**ZONING & PLATTING COMMISSION
ENVIRONMENTAL VARIANCE REQUEST REVIEW SHEET**

CASE: SP-2015-0004C

PROJECT NAME: Restoration Temple of Deliverance

DESCRIPTION OF VARIANCE: The applicant requests a variance from LDC Section 25-8-261, which prohibits development in a critical water quality zone.

SITE PLAN VARIANCE

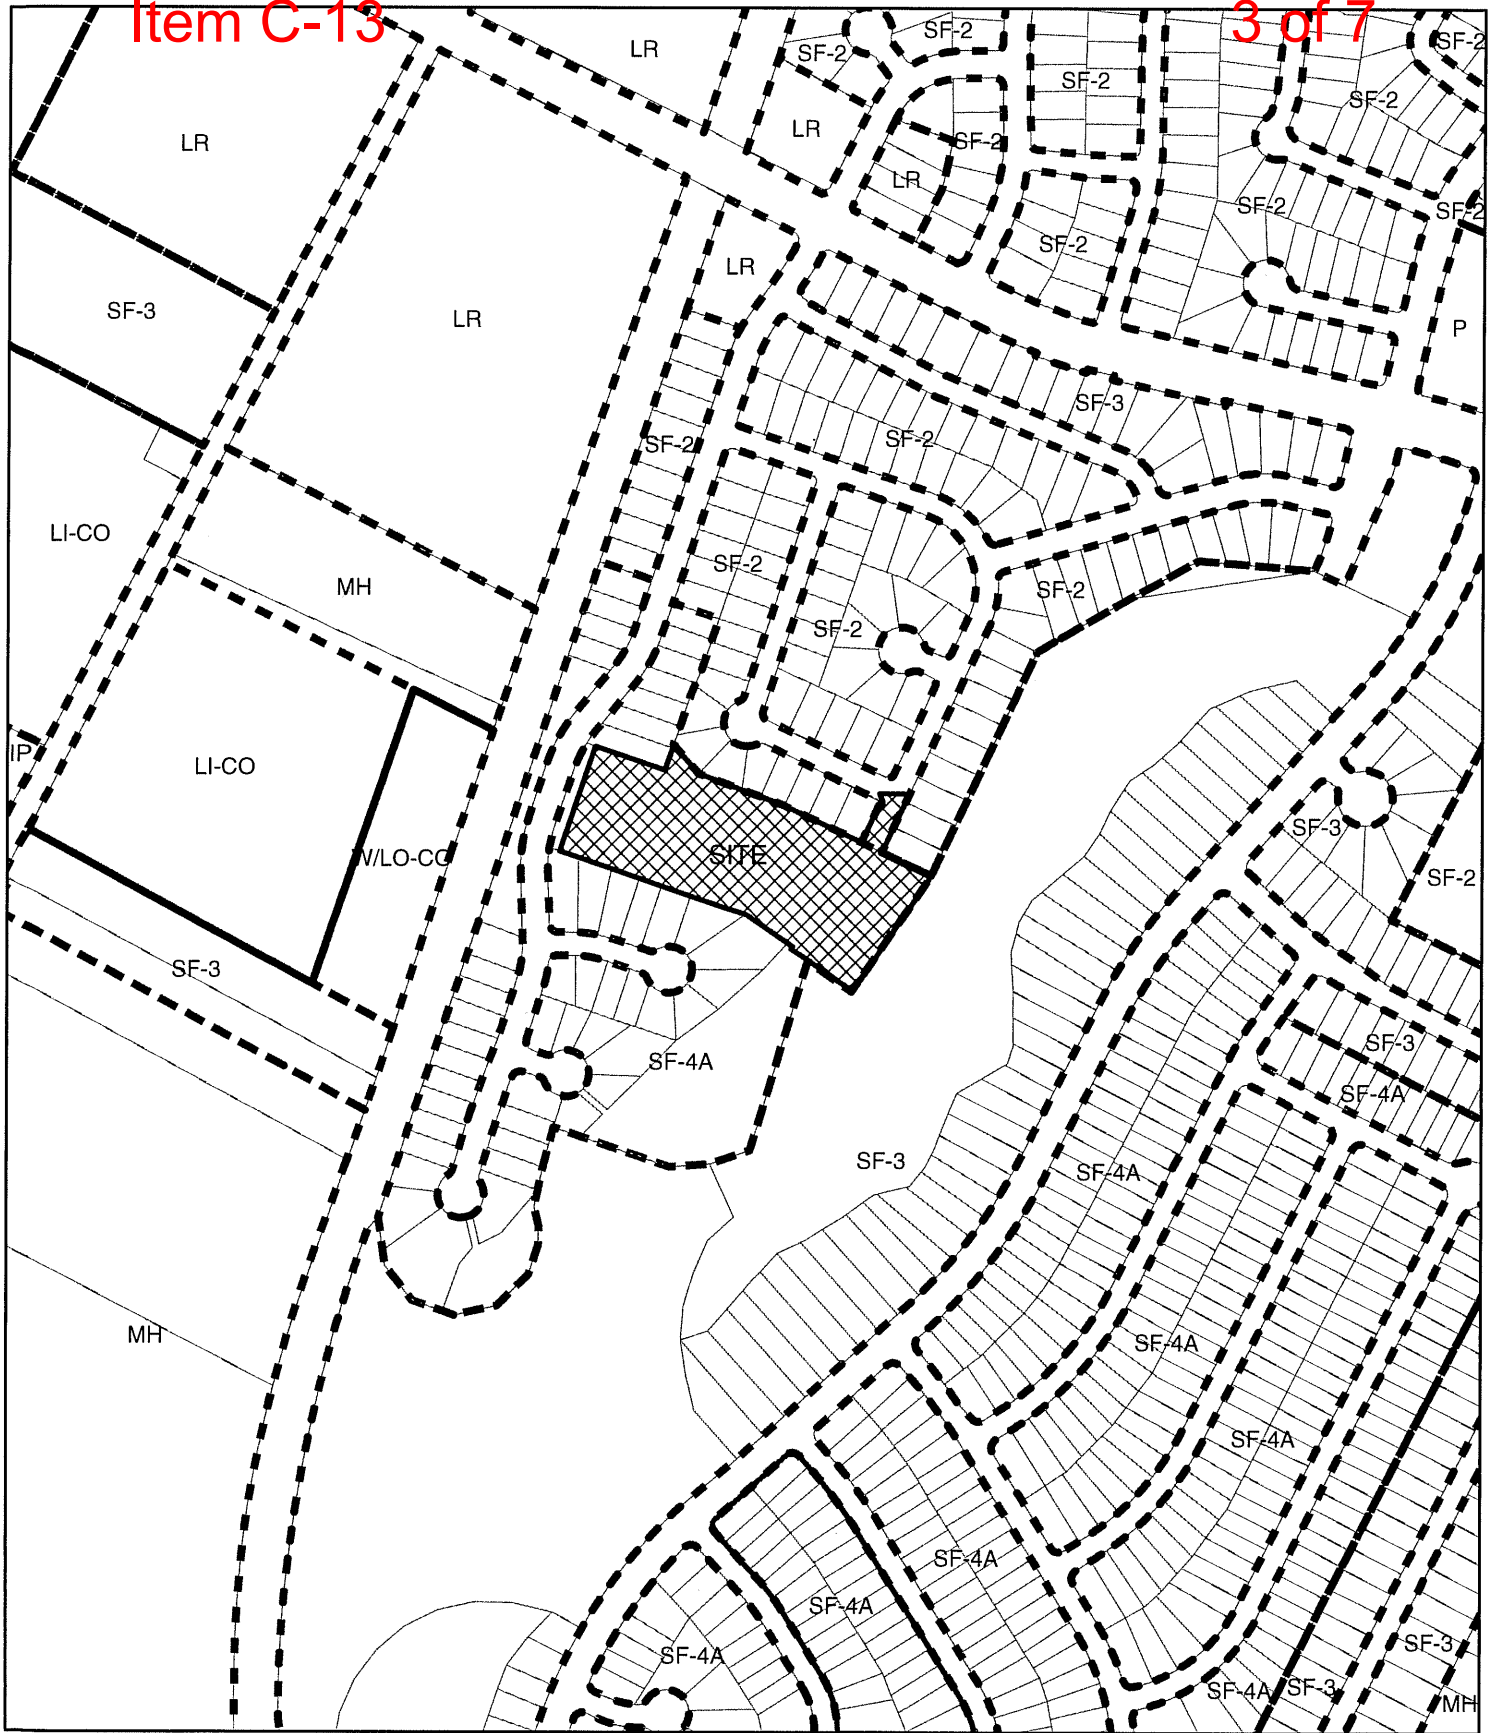
February 3, 2016: The Environmental Commission recommended approval of the variance request from LDC Section 25-8-261, to allow development in critical water quality zone in order to construct a primary access drive to the religious assembly site, with the following condition:

1. Evaluation of trees for screening along the north side of the site between the proposed driveway and existing homes.

Staff recommends approval with the following condition:

1. The applicant will provide educational signage for the wetland critical environmental feature and riparian buffer

Variance Request

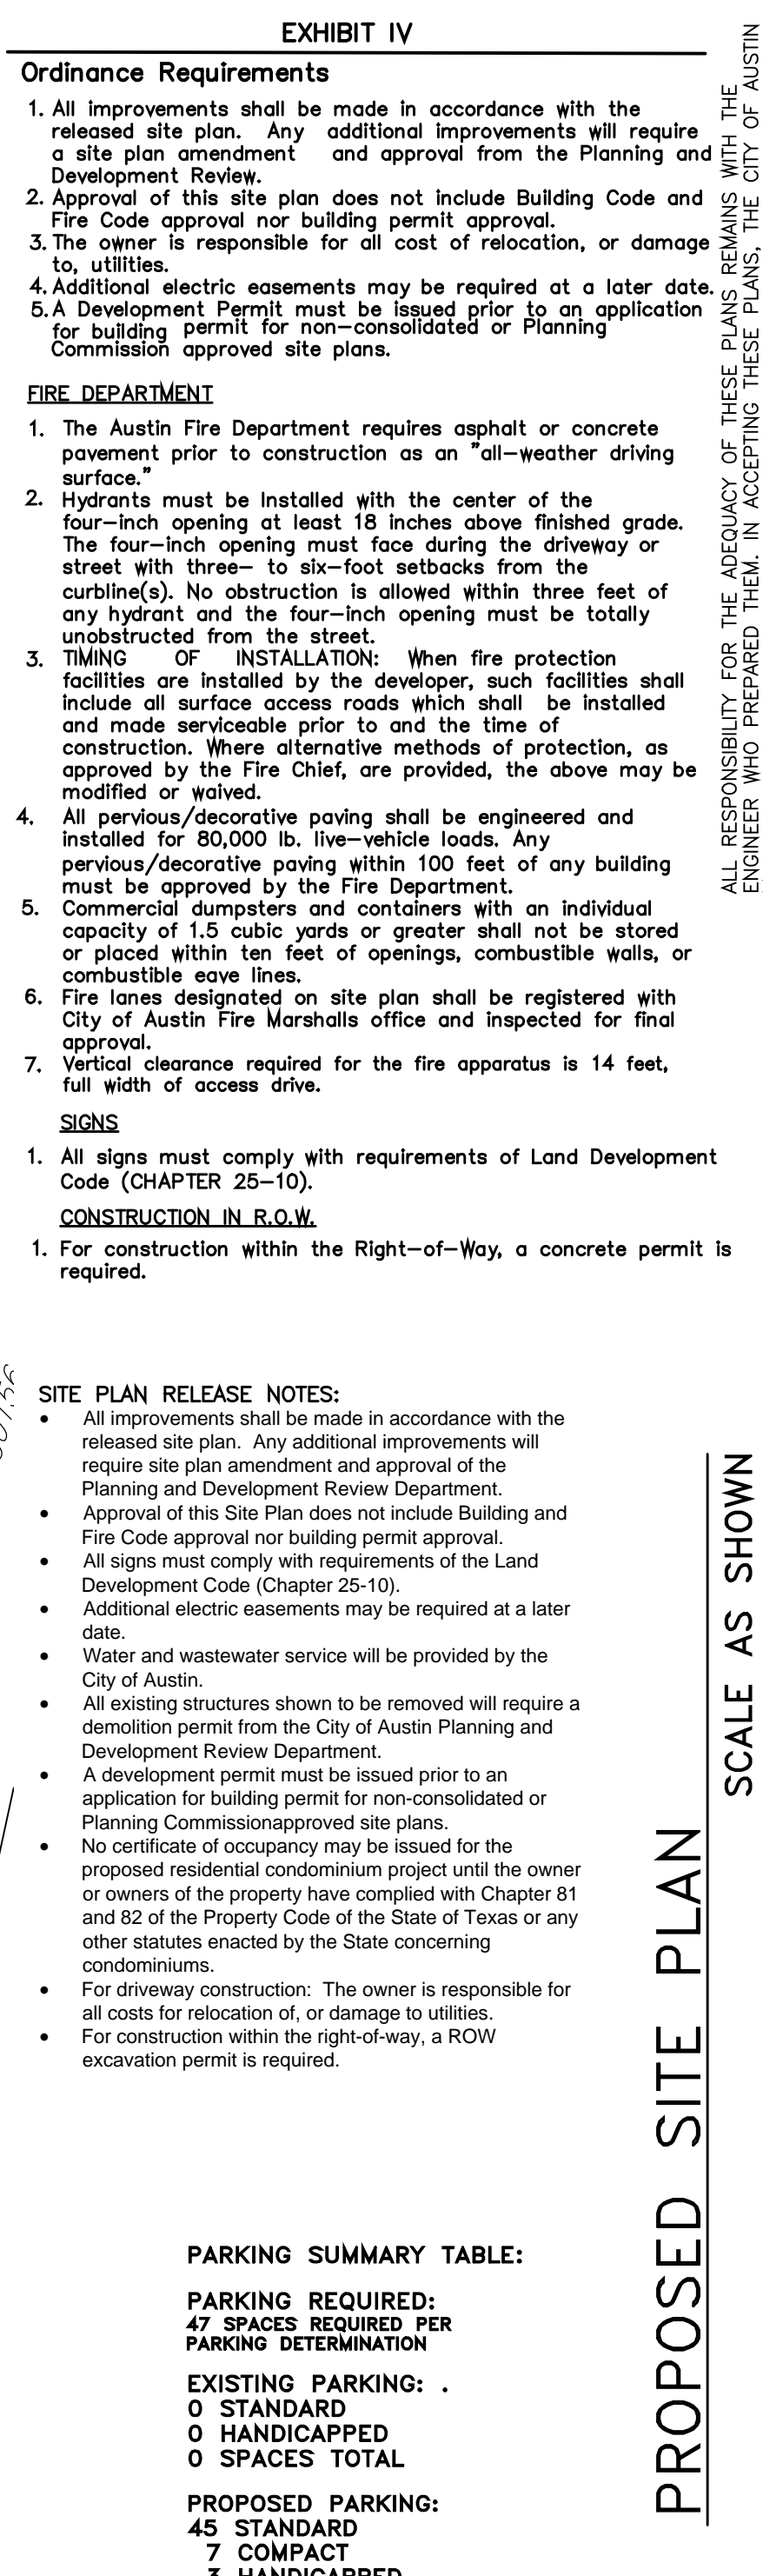
Land Development Code (LDC) Section 25-8-261 prohibits development in a CWQZ. The proposed driveway connecting with Moonglow Dr. encroaches on the CWQZ boundary.

Applicant to provide educational signage for the wetland CEF and riparian buffer.

Staff recommends approval of the variance.
